OSSF Inspection Sheet

Permit of Authorization to Construct an On-Site Sewage Facility Permit Valid For One Year From Date Issued

RE- SEPTIC DESIGN
282 SERENITY PASS
SERENITY OAKS, UNIT 4, LOT 133
SPRING BRANCH, TX 78070
HOLMES RESIDENCE

RE: Septic Design #117692
282 Serenity Pass
Serenity Oaks, Unit 4, Lot 133
Spring Branch, TX 78070
Holmes Residence

OWNER: D'ANN & LYNDELL HOLMES				DRAWN BY: EJS III	
STREET ADDRESS: 282 SERENITY PASS					
LEGAL DESC: SERENITY OAKS			UNIT/SECTION/PHASE: 4	BLOCK:	LOT: 133
PREPARED BY: GREG W. JOHNSON, P.E. F#002585		SCALE: 1"=40'	DATE: 6/28/2024		REVISED: 2/27/2025

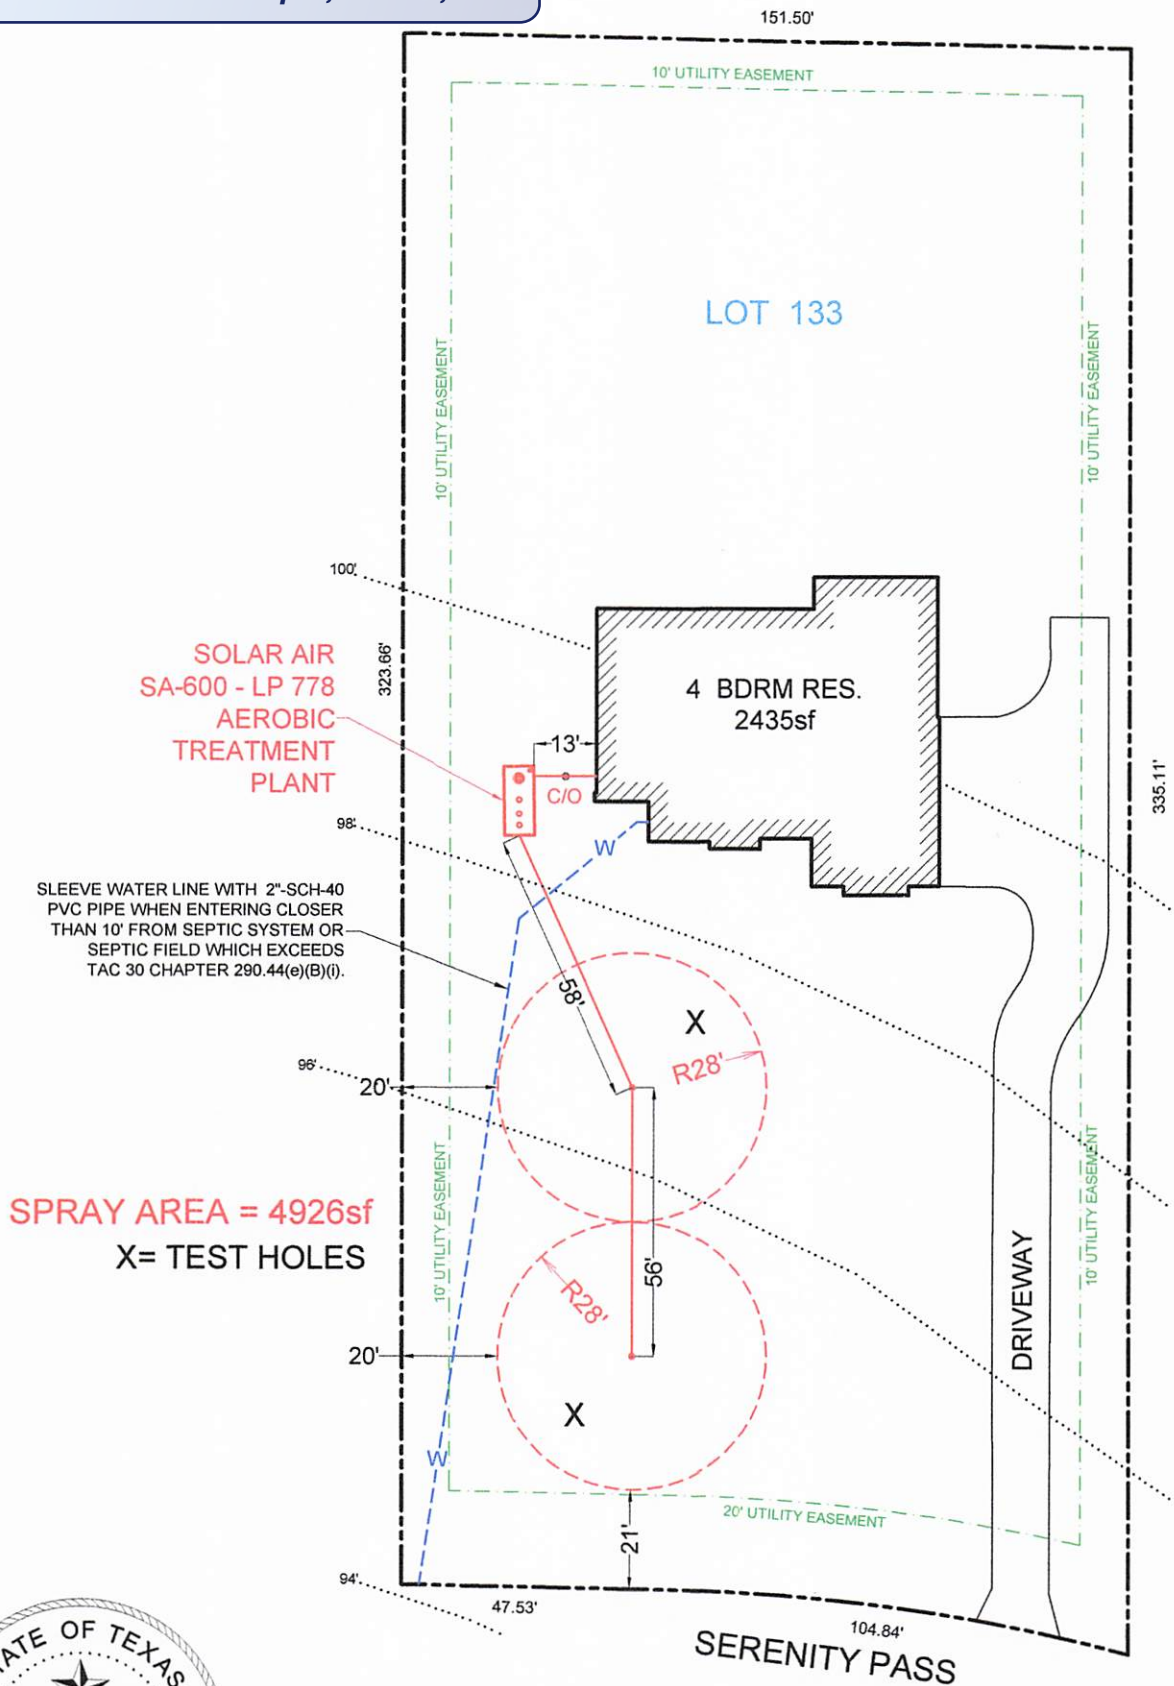
A portion of the waterline crosses the effluent line and is less than ten feet from the spray field. A variance is required to Chapter 285 Table X & 290.44(e)(8). Equivalent protection will be maintained by sleeving the water service line with SCH-40 PVC within ten feet of the septic system. I hereby request a variance to Chapter 285 Table X & 290.44(e)(8).
